PLANNING BOARD MEETING AGENDA

January 27, 2025 at 7:30 PM

Re: Wickes Arborists – 11 McNamara Road
Response to Site Plan and Special Permit Review comments

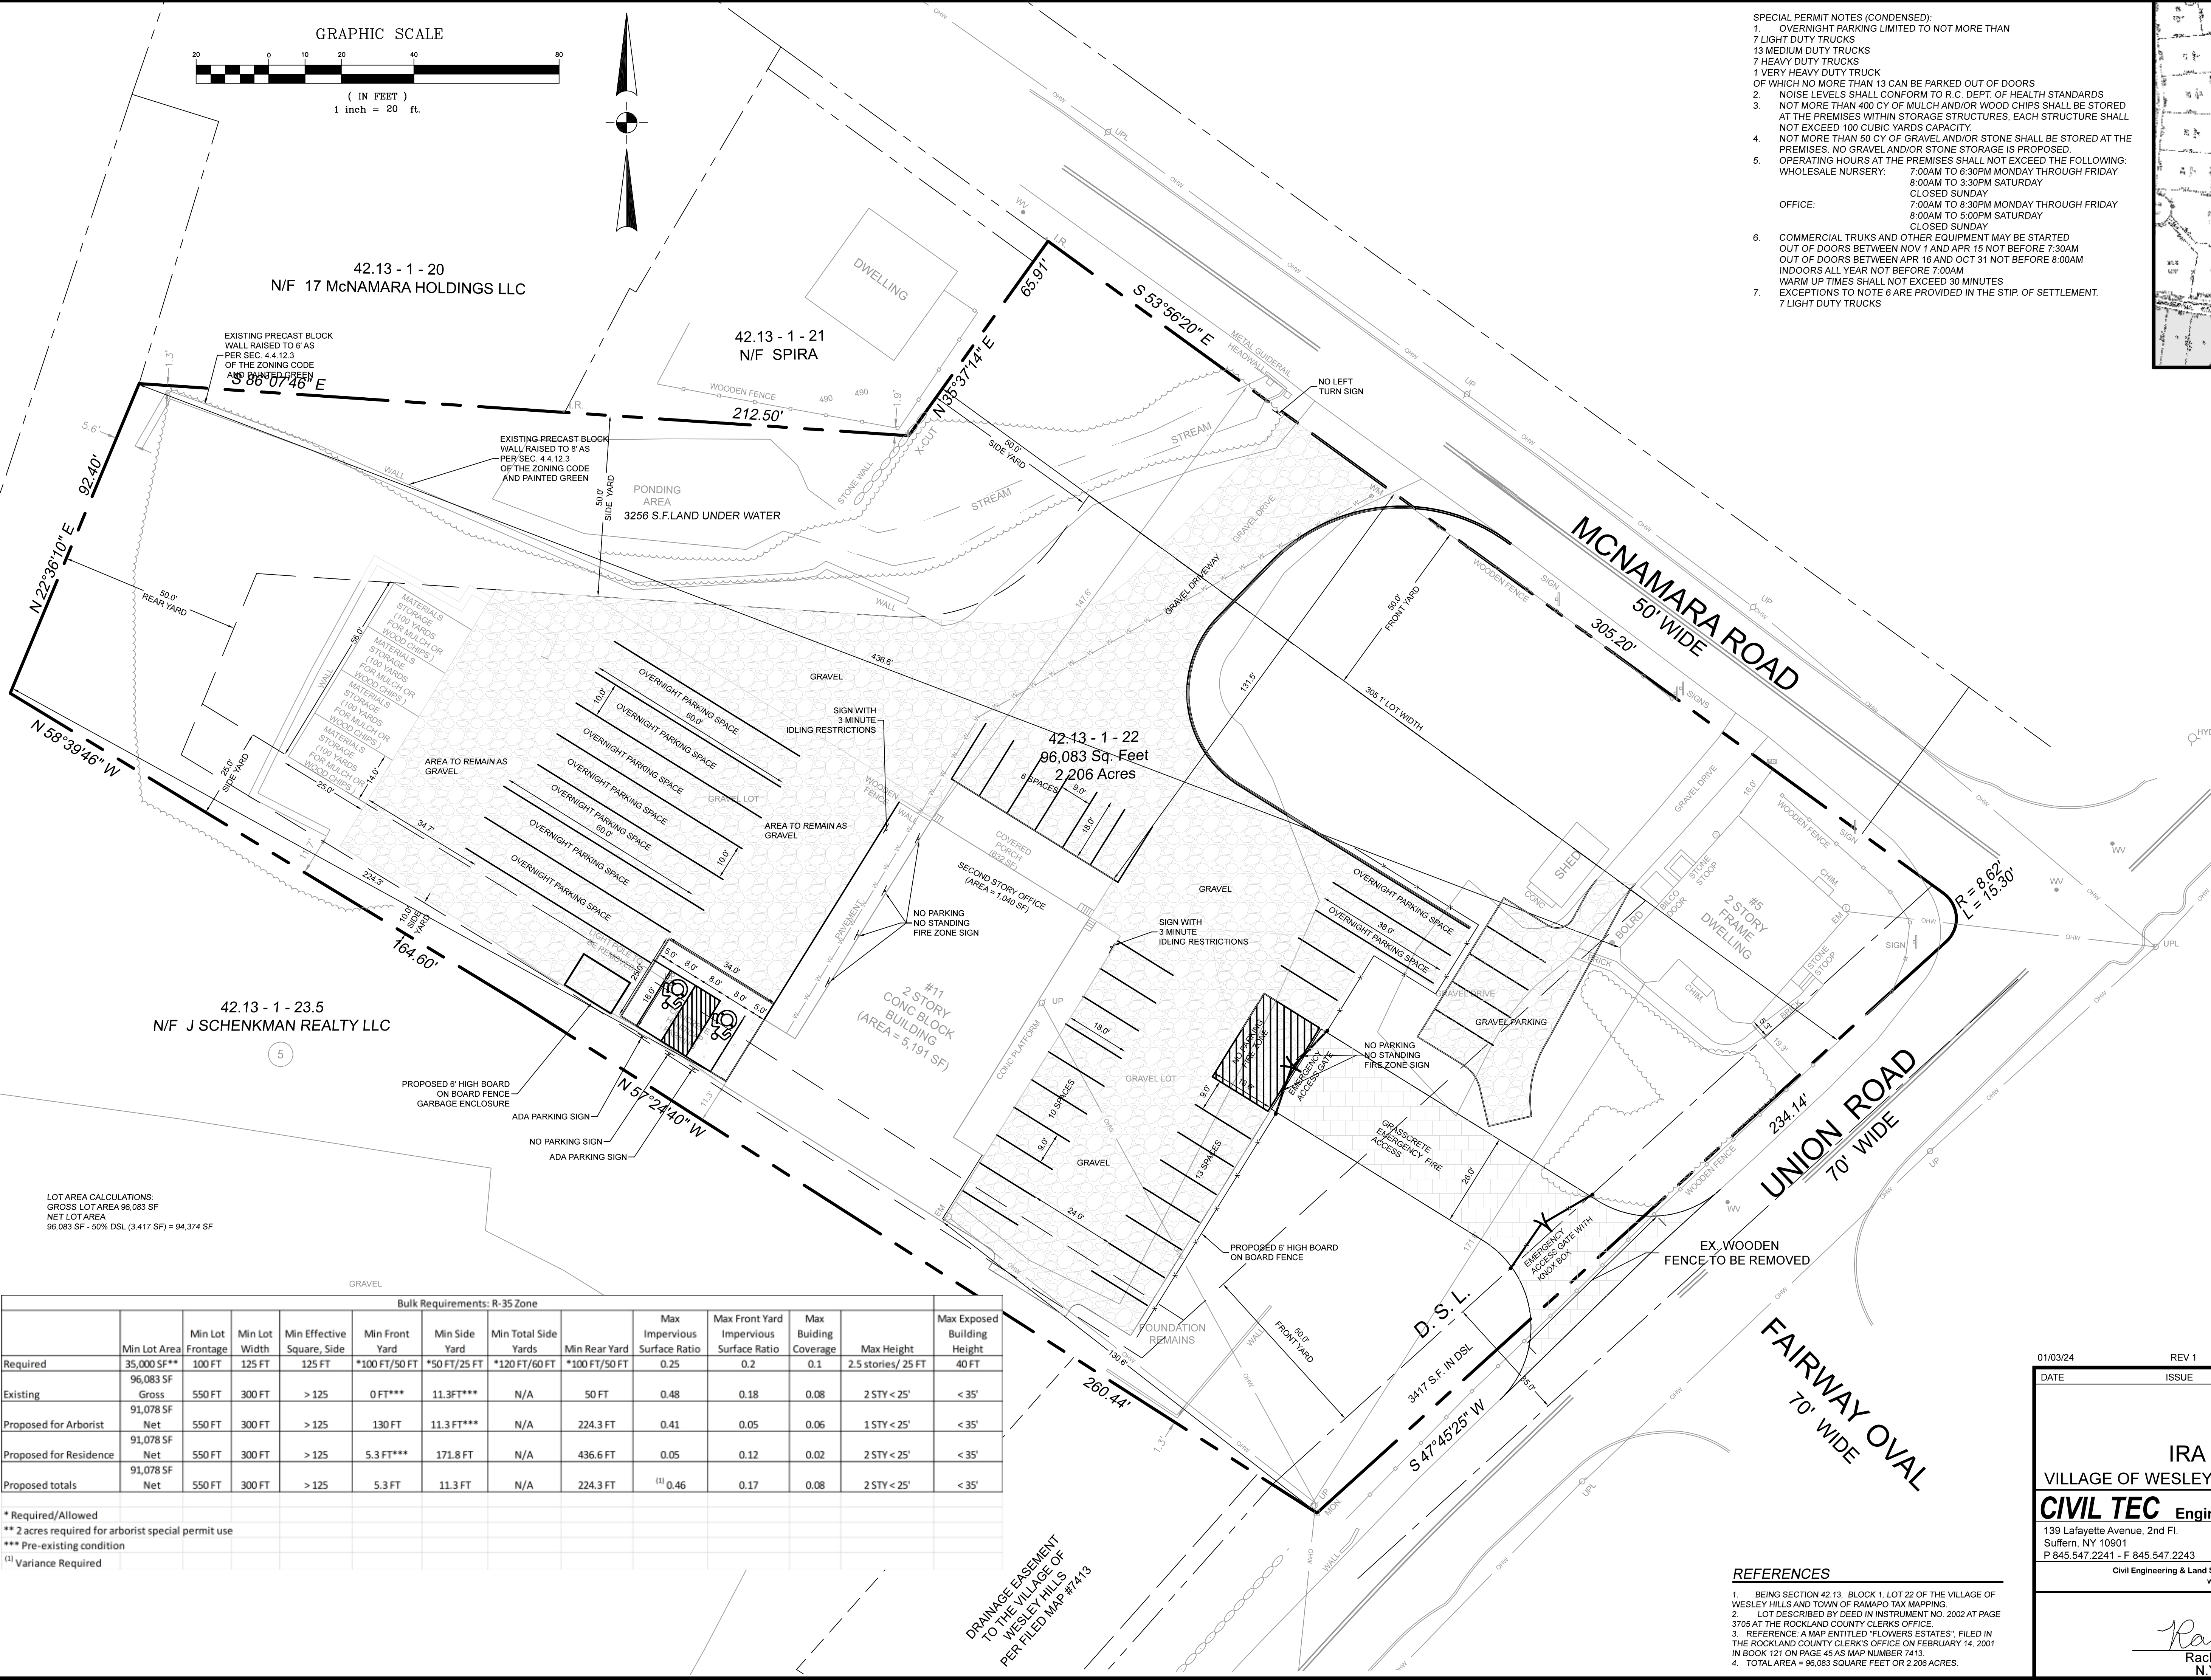
- 9. Various site plan elements appear to be absent from the previously approved site plan, including but not limited to:**

- a. "No left turn for trucks" signage
- b. Fire zone signage
- c. Proposed fence limits
- d. Block wall adjustments (or note current heights)
- e. Lighting Plan

A thorough review shall be performed to confirm all previously approved site plan elements have been incorporated to the new plans.

Response: A thorough review of the approved site plan was performed, and revisions were made to the plans.

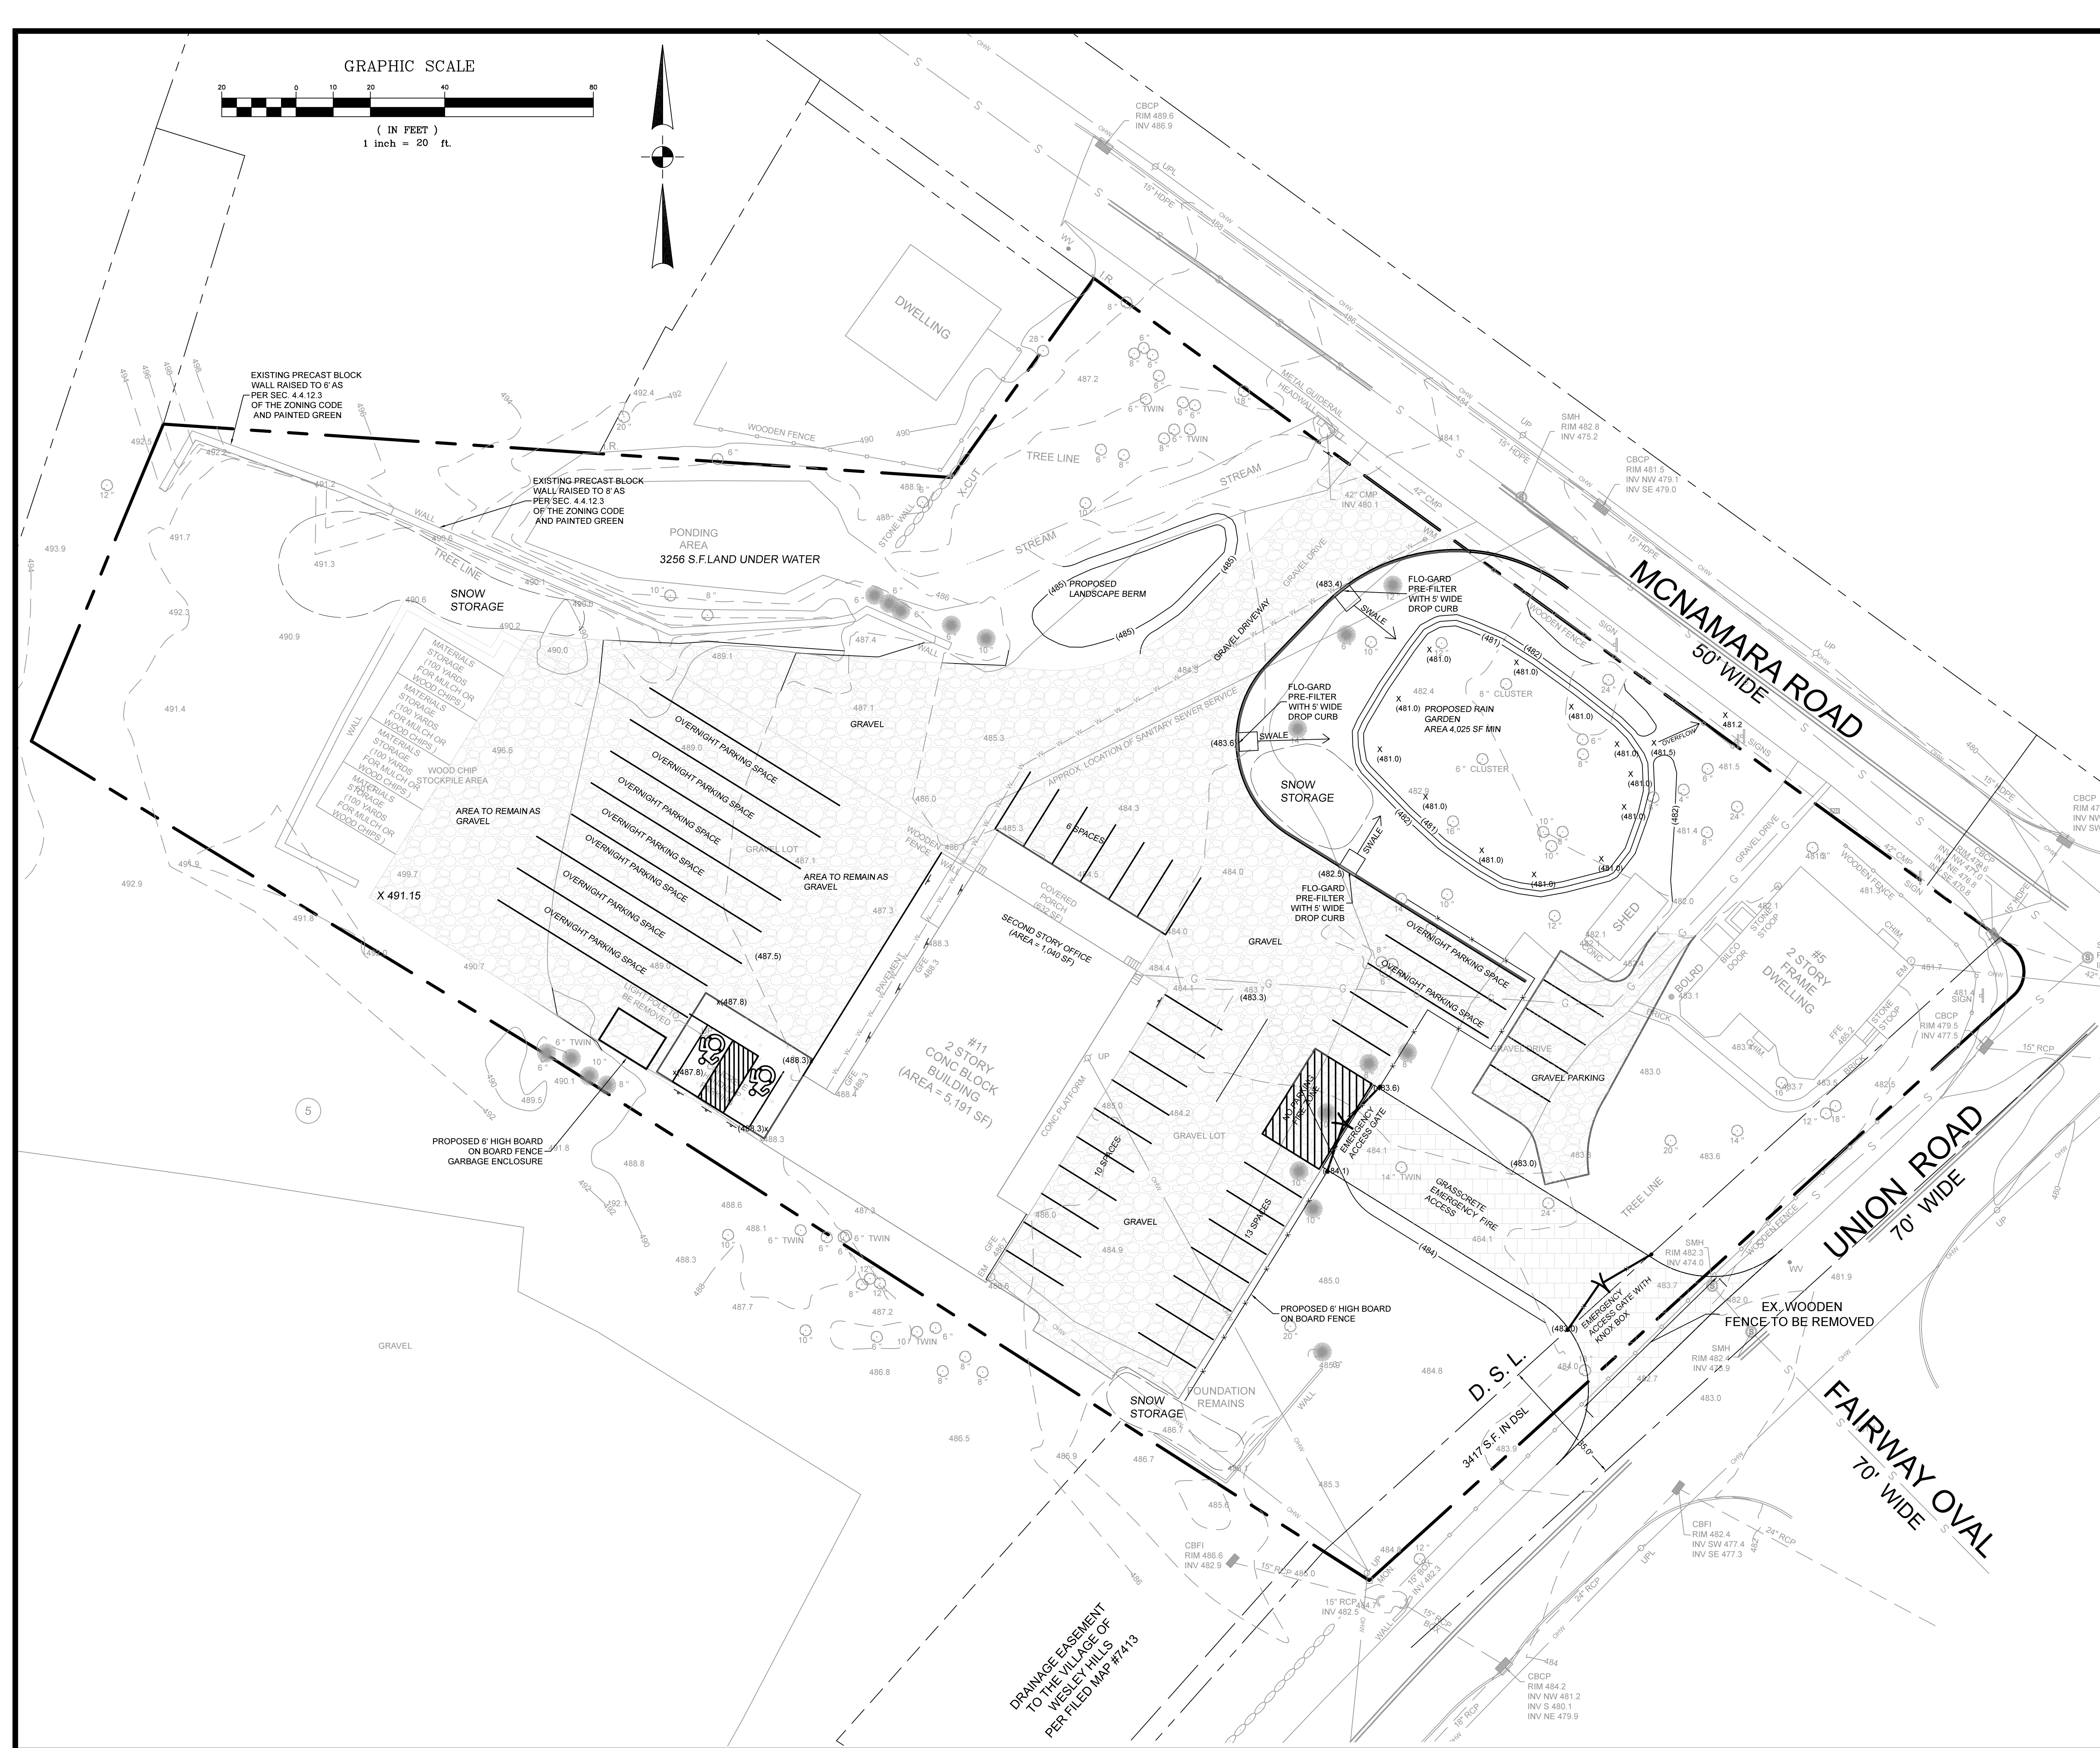
- 10. Grading detail is limited. Additional spot grades shall be provided to demonstrate:**

- 11. Additional drop curbs appear necessary to accommodate proposed configuration of catch basins/flo-gard prefilters. Outlet of catch basin to be clarified. Detail suggests a piped overflow is needed. Grading/inverts to be confirmed.**

- 13. The discharge point for the underdrain system and domed overflow riser are absent from the plan. Overflow invert, underdrain invert, and discharge location & invert shall be provided.**

Response: Additional spot grades have been provided to clarify the proposed grading in the named areas.

Response: An additional Drop curbs and an additional flo-gard pre-filter have been proposed. The overflow has been designed to flow overland in a grass swale to McNamara Road drainage system. An underdrain is not required in the rain garden if the soil infiltration rate is not sufficient. If soil testing determines an underrating is required, we will design it before construction.

Response: Overflow has been designed to flow overland in a grass swale to McNamara Road drainage system.
